PREVOST

**SAFETY
RECALL**

SR23-08

DATE :	April 2023	SECTION :	18 BODY
SUBJECT:	Emergency Exits - Release Mechanism Tension

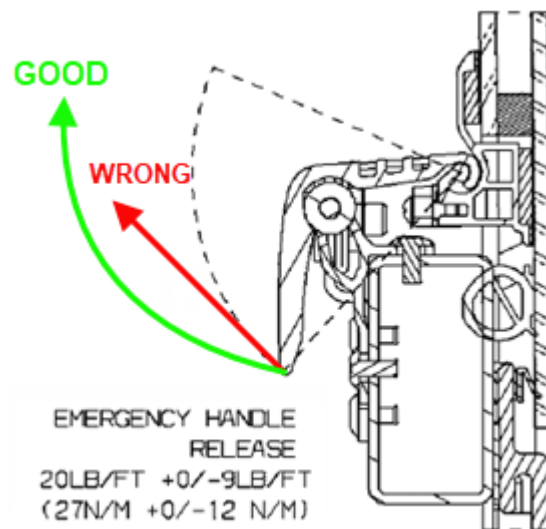
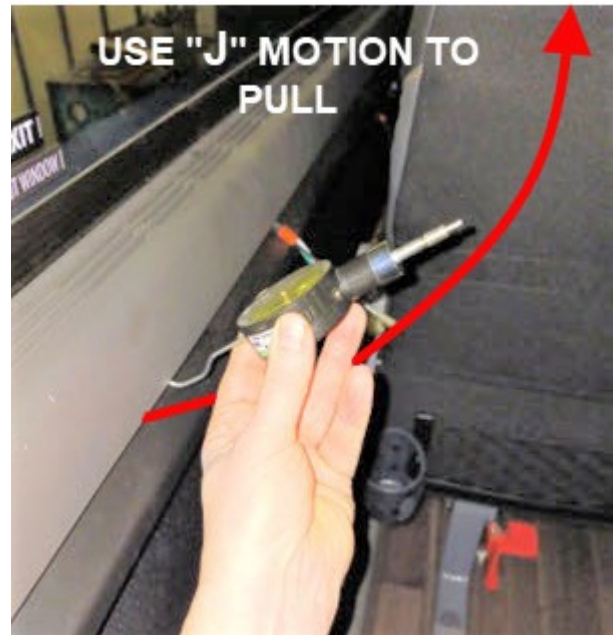
- Install the tool hook in the middle of the window handle.
- Point the tool upward at a **45deg angle** (with the floor).
- *Slowly* pull with the tool until the handle unlatches (use a "J" motion, do not pull straight).
- Take this measurement twice to make sure readings are consistent. Take note of the average pull weight.

IMPORTANT : Use a « J » motion when pulling, do not pull straight at 45deg

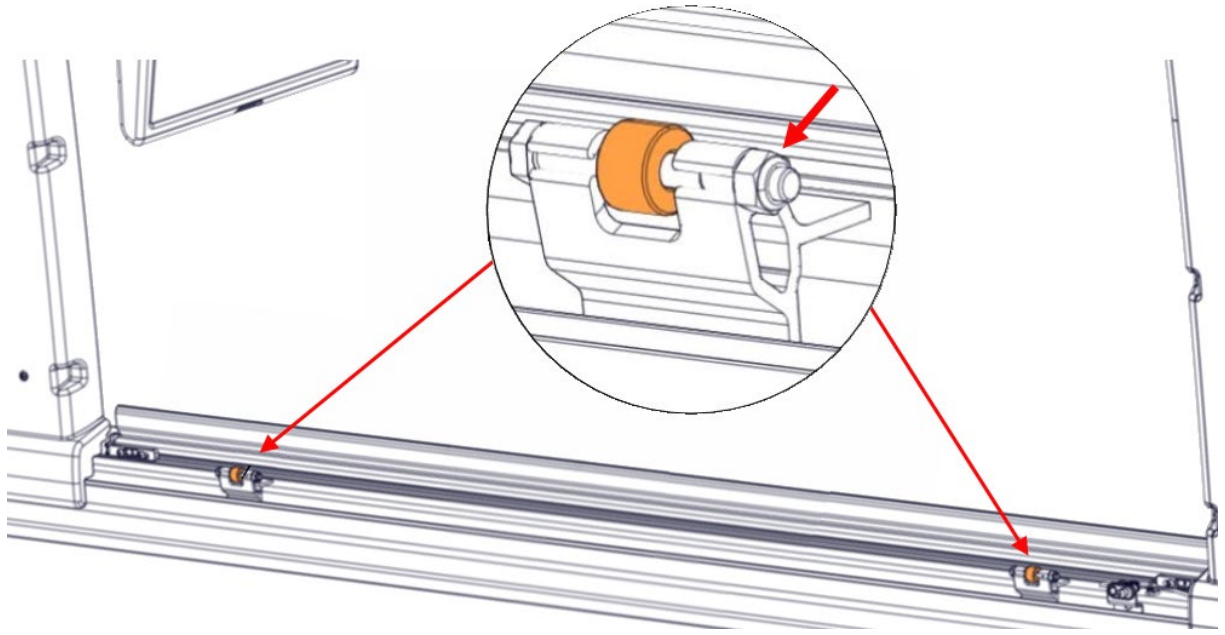
2. Pull weight should not exceed 20LB (90N) If the pull weight is over the limit, the two handle rollers must be replaced.

- Rollers are located on both sides under the handles.
- To remove the roller, simply unscrew the retaining nut and slide the screw acting as a roller shaft.
- Clean the screw and reinstall new supplied **290576** low tension roller (smaller diameter).
- Put a light coat of red synthetic grease on the new roller (Prevost **683652** recommended).
